HOLDOVER/REVISED**PLANNED UNIT DEVELOPMENT
& SUBDIVISION STAFF REPORT****Date: March 7, 2013****DEVELOPMENT NAME**

Turner Marine Supply Subdivision

5010 Dauphin Island Parkway
(West side of Dauphin Island Parkway extending to the
East side of Dog River)

Subdivision approval to create three legal lots of record from four metes and bounds parcels and Planned Unit Development Approval to allow multiple buildings on a single building site and shared access across multiple building sites.

SITE PLAN

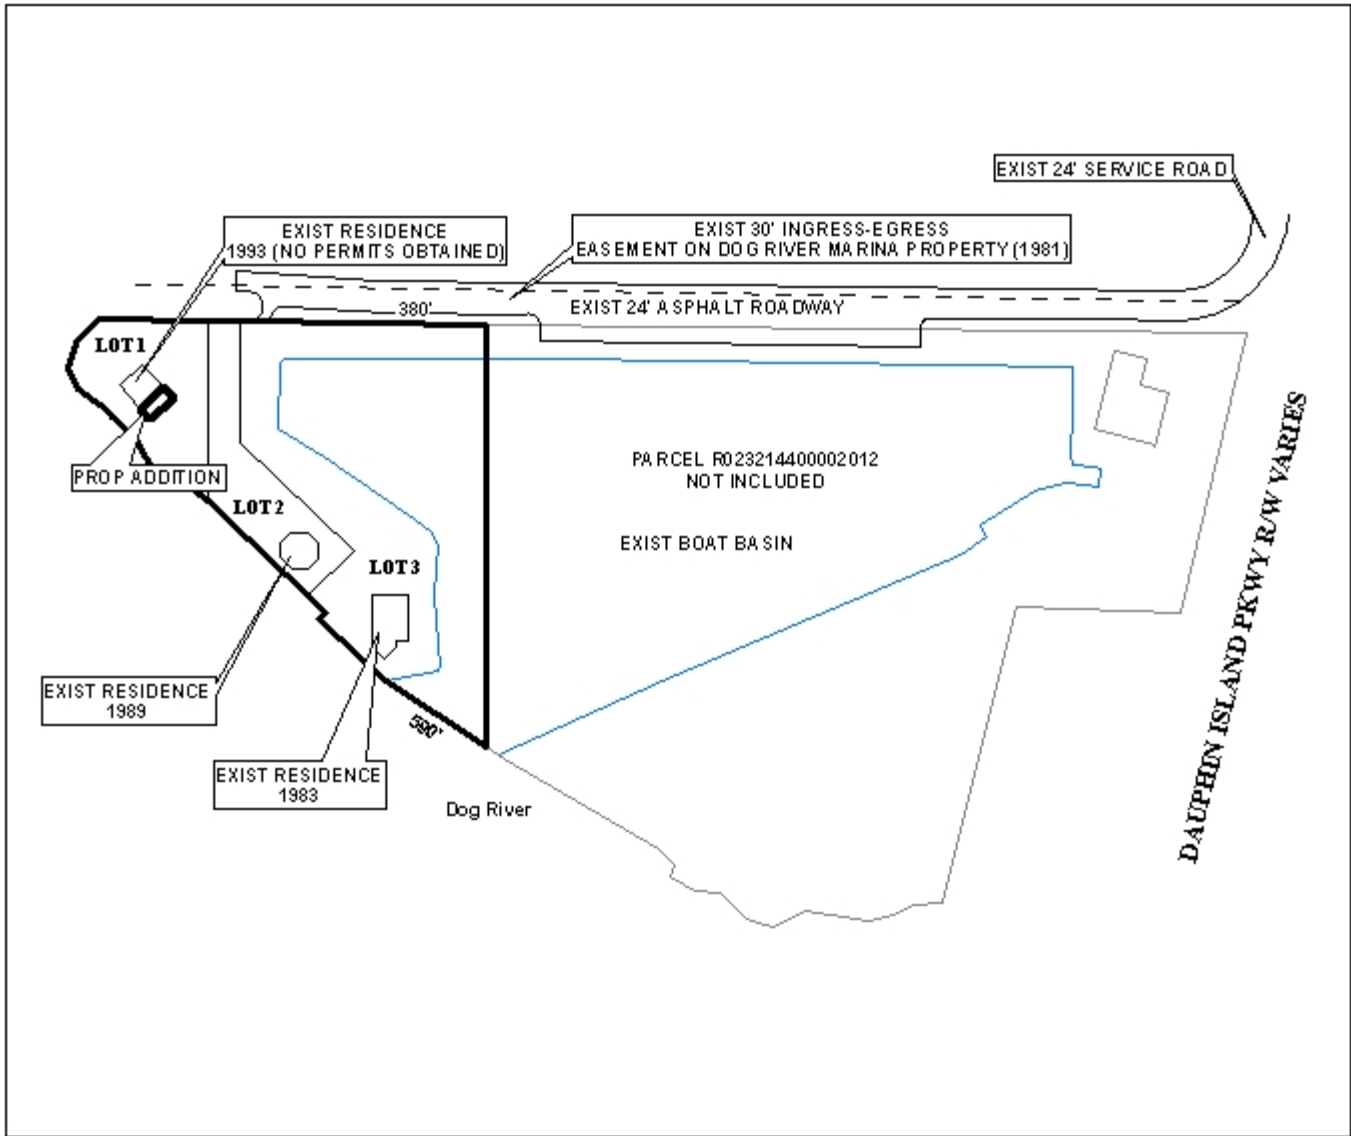
Since the applicant proposes an addition to one of the existing unpermitted dwellings and the history of parceling off a metes and bounds parcel was the catalyst for the submission of the Subdivision and PUD applications. The PUD site plan submitted ONLY indicates the proposed lot layout and existing building footprints with no building and setback dimensions. Therefore, the site plan should be revised to indicate the existing features of the entire site, including dimensions and square footage of all structures, the number of existing boat slips, the number of dry dock boat storage spaces, the number of parking spaces for vehicles and the amount of landscaping and location of existing trees. The site plan does not indicate a dumpster or contain a note stating how trash pick-up is proposed. Therefore, the site plan should be revised to indicate a dumpster, in compliance with Section 64-4.D.9. of the Zoning Ordinance, and with a compliant sanitary sewer connection, or a note should be placed on the site plan stating that trash collection will be curb-side pick-up or private pick-up service.

- 2) the submission of a Sidewalk Waiver application, requesting the waiver of the sidewalk along Dauphin Island Parkway;
- 3) illustration on the site plan the footprint dimensions, proposed additions and dimensions of the lot;

- 4) illustration of the number of boat slips, the number of dry dock boat storage spaces, the number of parking spaces for vehicles;
- 5) revision of the site plan to provide a dumpster, in compliance with Section 64-4.D.9. of the Zoning Ordinance, and with a compliant sanitary sewer connection, or the placement of a note on the site plan stating that trash collection will be curb-side or via private pick-up service;

The applicant submitted a revised site plan; however, this site plan did not illustrate compliance with requirements as requested by staff at the February meeting.
